275 Alfred Street, North Sydney SSD-86992219 - Public Exhibition Submission - Objection

This letter has been prepared by CASA, the owners of 45 McLaren Street, North Sydney, in response to the proposed shop-top housing development at 275 Alfred Street, which is currently on public exhibition until 20 January 2026.

Figure 1 – Solar Access Assessment – little Alfred Part (as extracted from page 42 of the Design Report)

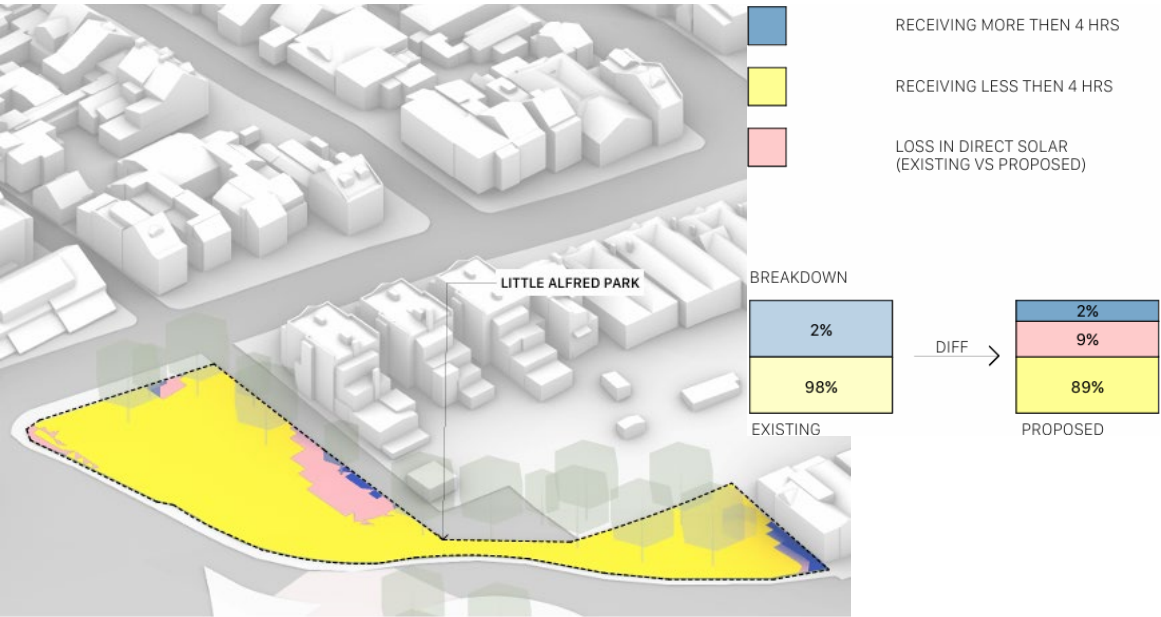
However, the shadow analysis contained within the Design Report is inconsistent and misleading. Figure 1 below (as extracted from page 42 of the Design Report) indicates that, under existing conditions, the majority of Little Alfred Park receives less than four hours of solar access. This outcome is not reflected in the shadow diagrams in Figure 2 below (as extracted from page 78 – 84 of submitted Design Report), which show the park as only partially overshadowed at 9.00am and 10.00am and fully overshadowed at 3.00pm by existing buildings. Based on Figure 2, the majority of the park in fact appears to receive approximately five hours of solar access under existing conditions, with only minor impacts at 9.00am and 10.00am. These inconsistencies call into question the accuracy and reliability of the submitted overshadowing analysis.

We request that the proposal be amended to prevent further loss of solar access to Little Alfred Park, consistent with the DCP.

Figure 2 Shadow Diagrams – Little Alfred Park (Page 78 – 84 of submitted Design Report)

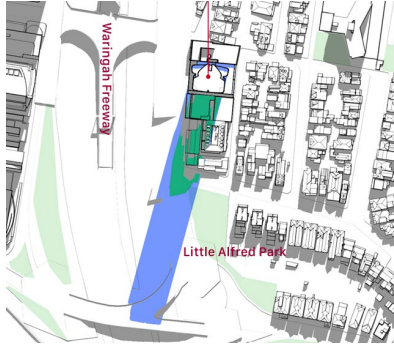
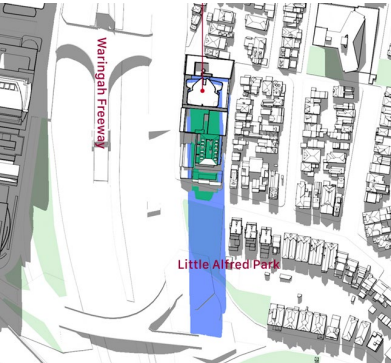
Notwithstanding these discrepancies, Figure 2 below clearly demonstrates that the proposed development would result in additional overshadowing of Little Alfred Park between approximately 11.00am and 1.00pm, with the majority of the park overshadowed at 12.00pm. Figure 1 below further identifies that, under the proposed scenario, 9% of the park would receive no solar access during the winter solstice. These impacts directly conflict with Section 5.2 of the DCP and highlight the excessive scale and bulk of the proposed development.
